September 7, 1984

HOPE CREEK GENERATING STATION
DOCKET NO. 50-354
DRAFT SAFETY EVALUATION REPORT
OPEN ITEM STATUS

Attachment 1 is a current list which provides a status of the open items identified in Section 1.7 of the Draft Safety Evaluation Report (SER). Items identified as "complete" are those for which PSE&G has provided responses and no confirmation of status has been received from the staff. We will consider these items closed unless notified otherwise. In order to permit timely resolution of items identified as "complete" which may not be resolved to the staff's satisfaction, please provide a specific description of the issue which remains to be resolved.

FIGURE 9.1-32
SHEET 1 OF 12

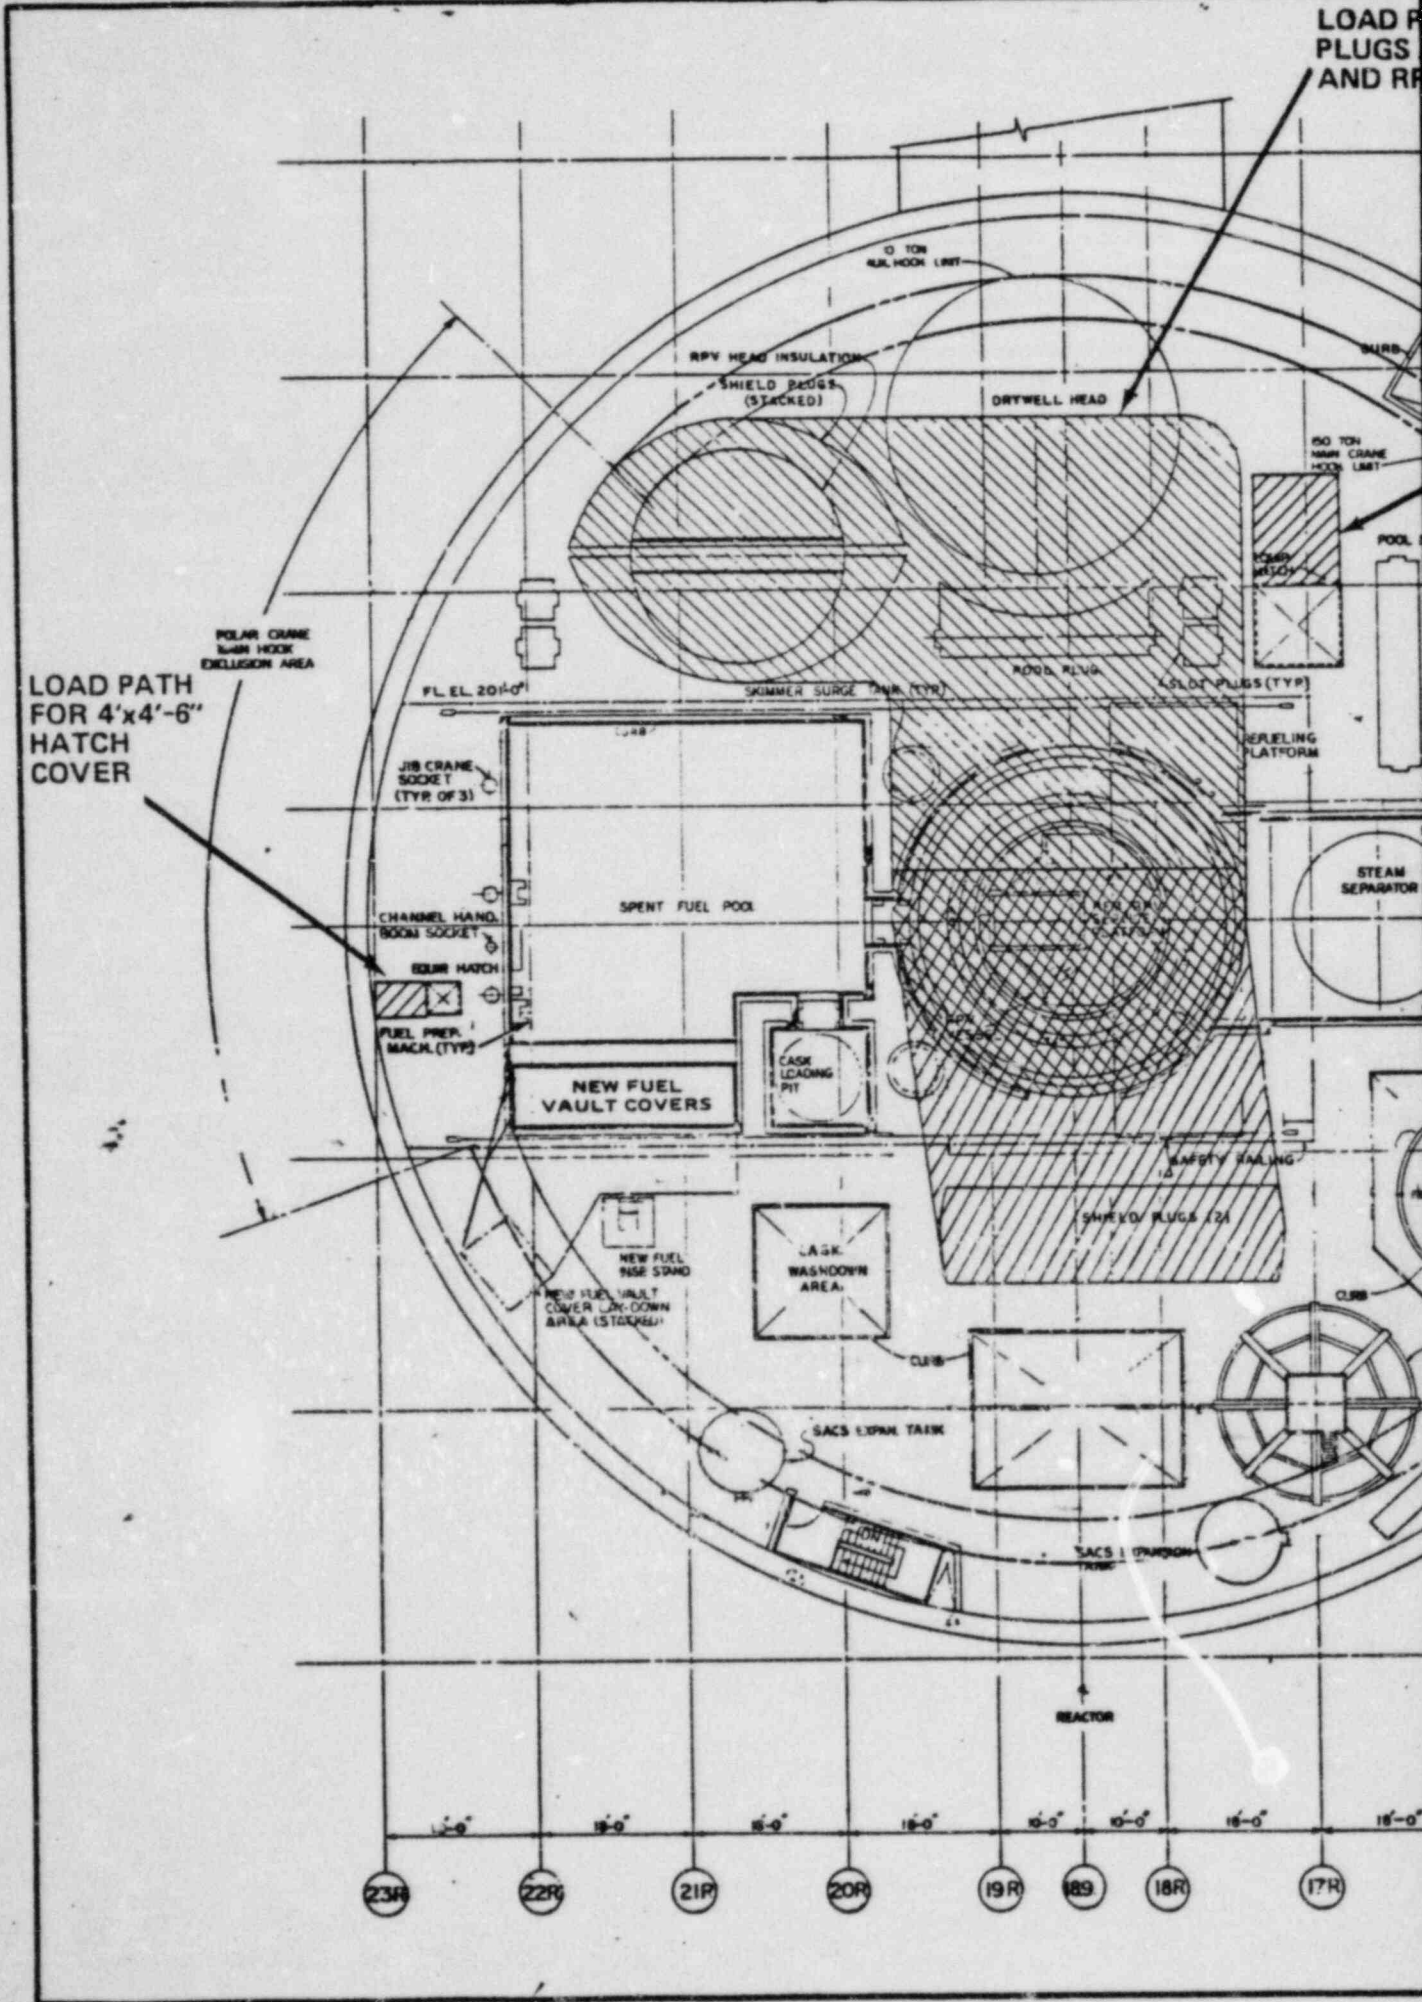
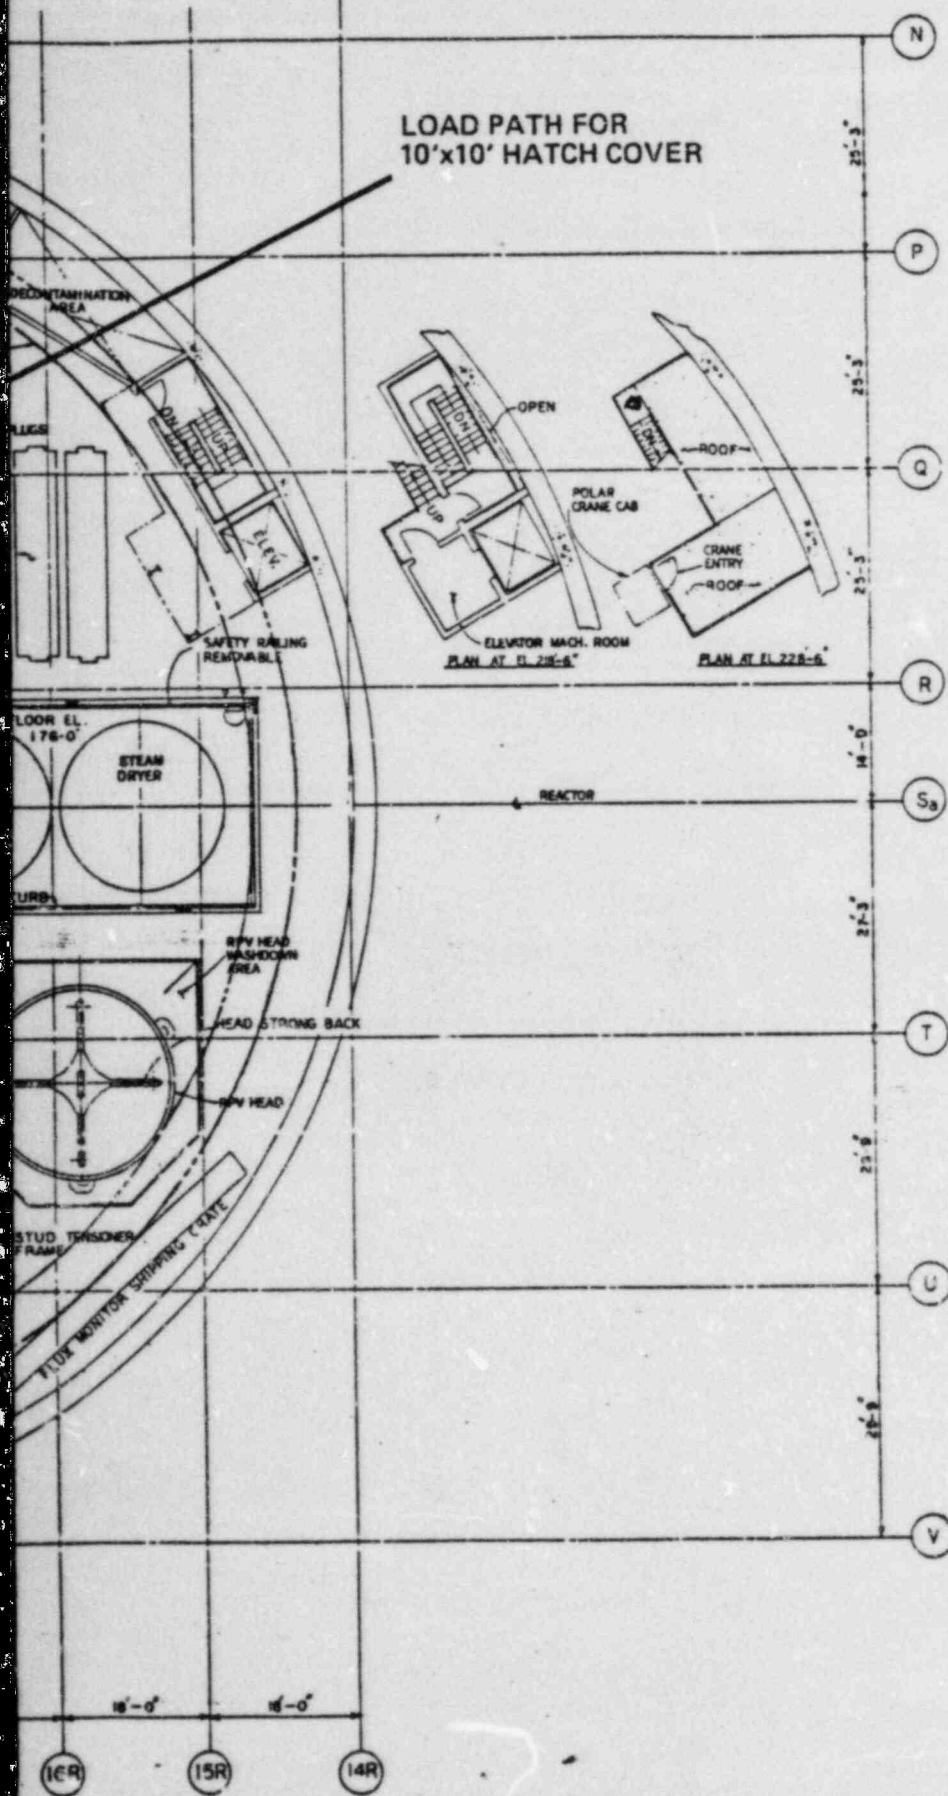
The load paths for the seven loads listed in Item B.3.a of DSER, Appendix A have been added to Figure 9.1-32. The 4-ft by 4-ft. hatch and the 10-ft by 10-ft hatch paths were added to Sheet 1 of Figure 9.1-32; the spent fuel gates path and the flux monitor shipping crate paths were added to Sheet 2; Sheet 6 was added for the refueling bellows guard ring path; Sheet 7 was added for the channel handling boom crane path; and Sheet 8 was added for the RPV head stud rack path.

The load path for the new fuel vault covers has been deleted from Figure 9.1-32, Sheet 1, because the covers are not heavy loads. Each of the three sections is made of 0.25 in thick steel plate and weighs less than 900 pounds.

FIGURE 9.1-32
-SHEET 9 OF 12

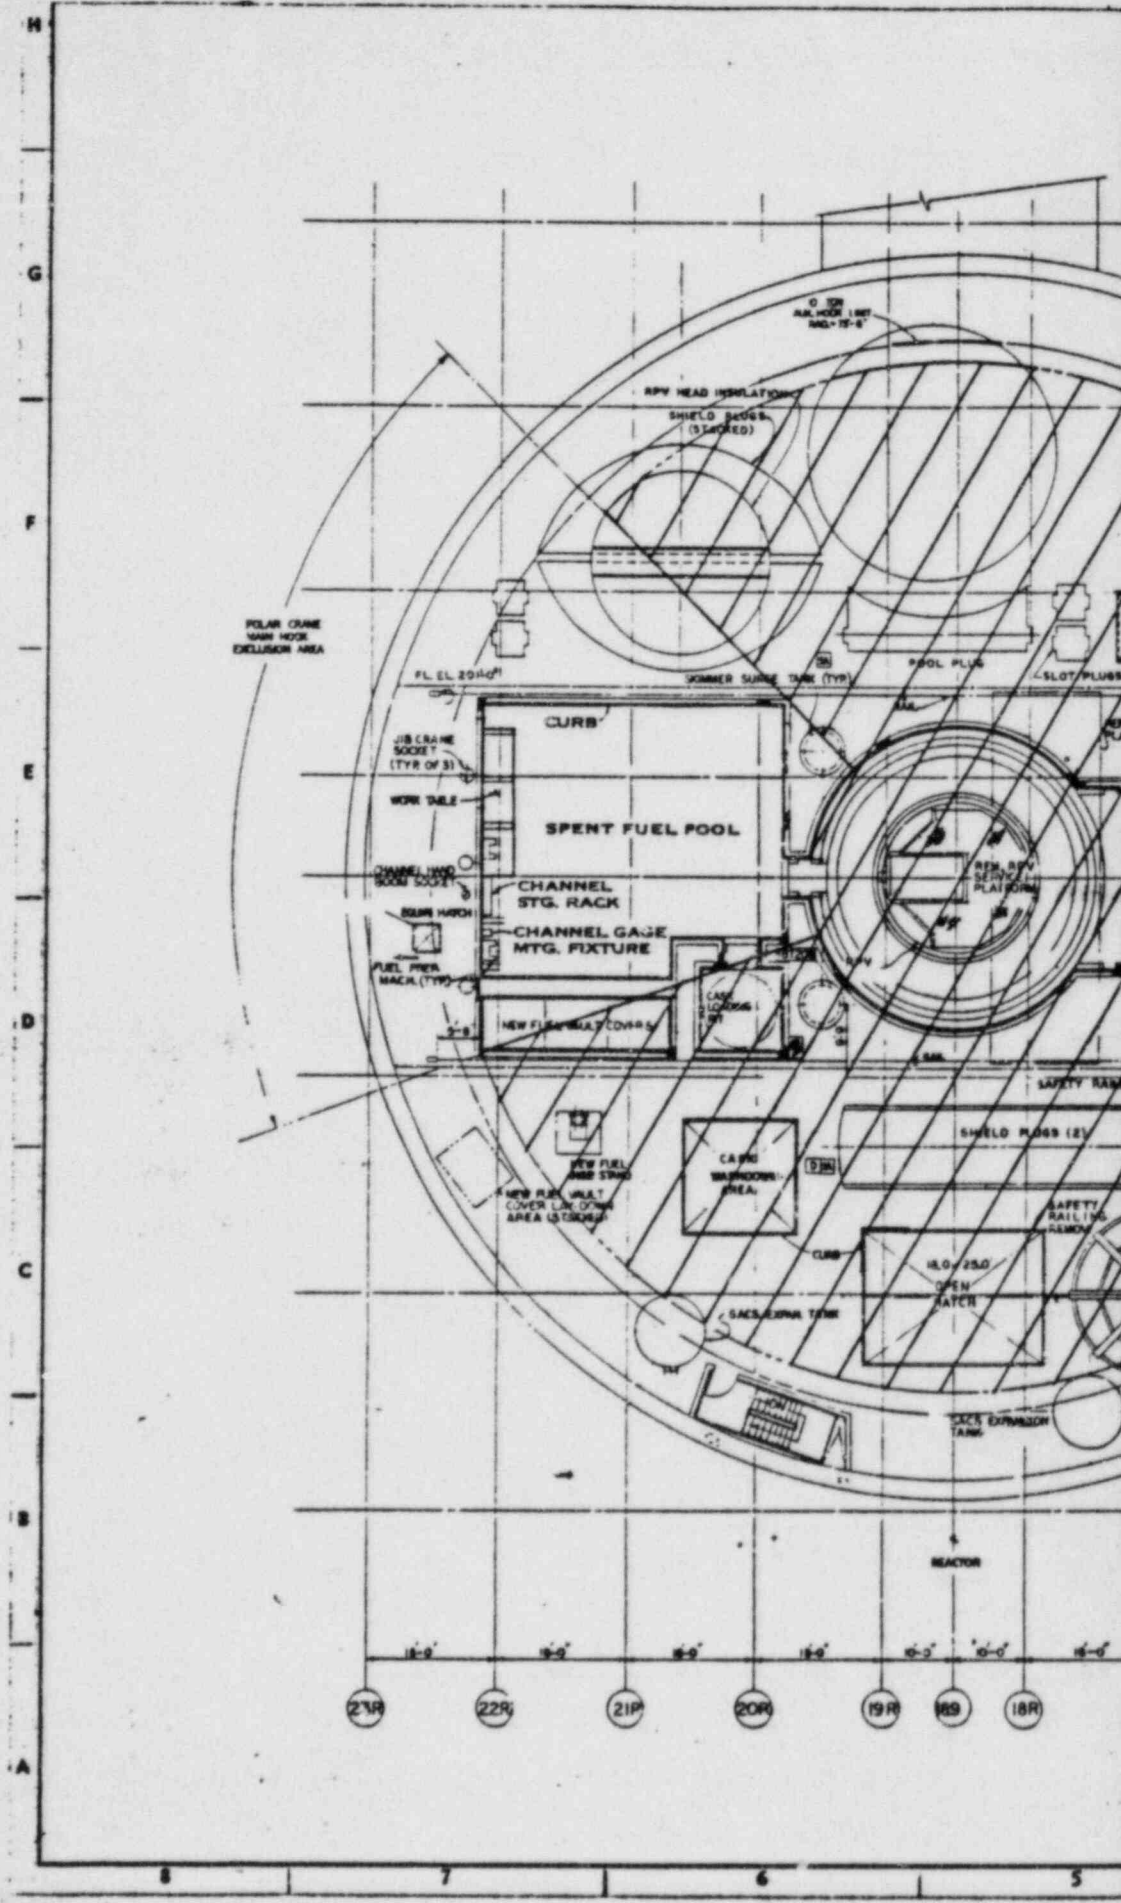
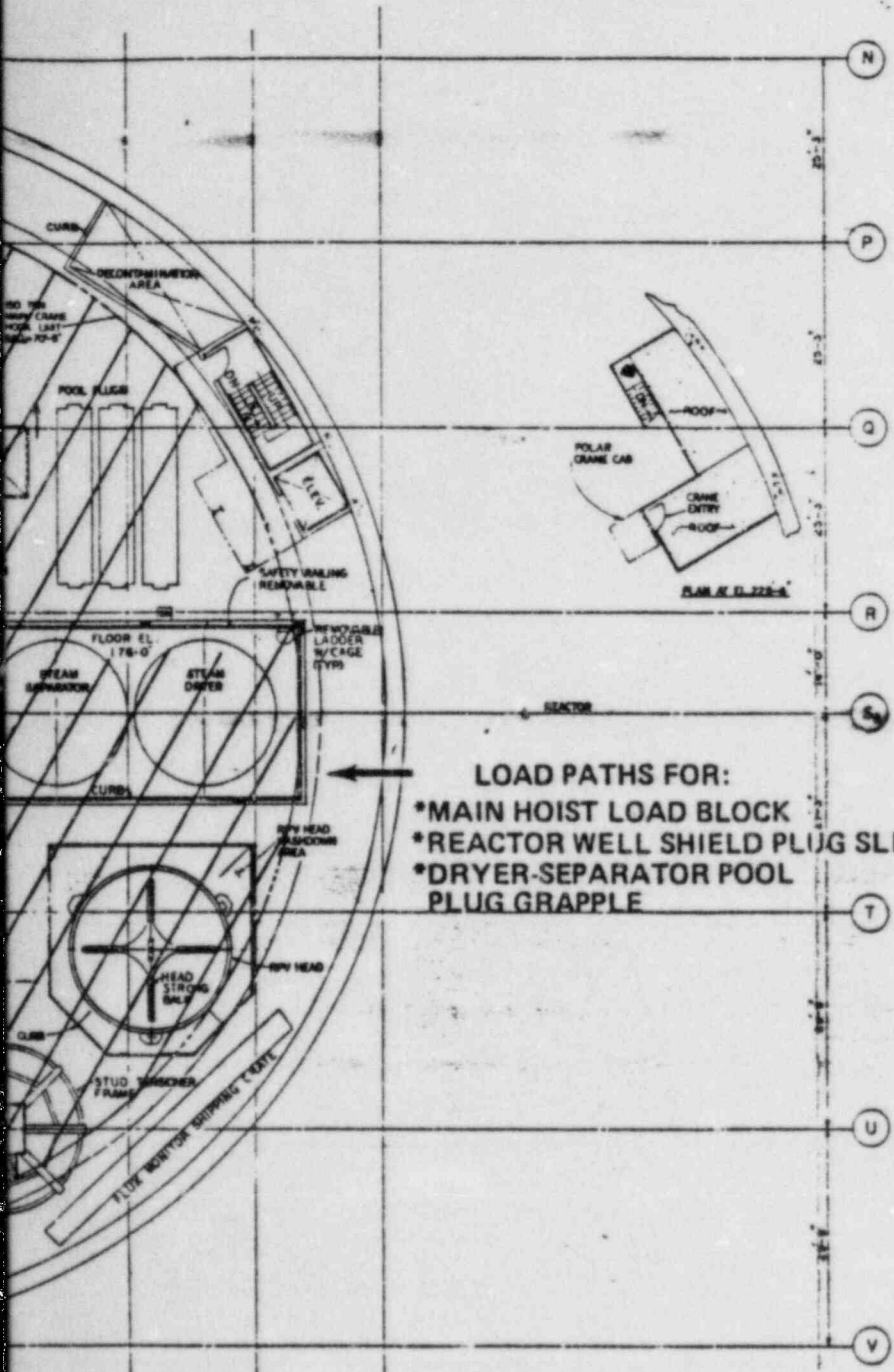
Safe load paths for three additional polar crane heavy loads that are listed in Table 9.1-12, but not mentioned in Item B.3.a of DSER, Appendix A, have been added to Figure 9.1-32. The main hoist load block, auxiliary hoist load block, and spent fuel cask yoke are shown on new Sheets 9, 10, and 11, respectively.
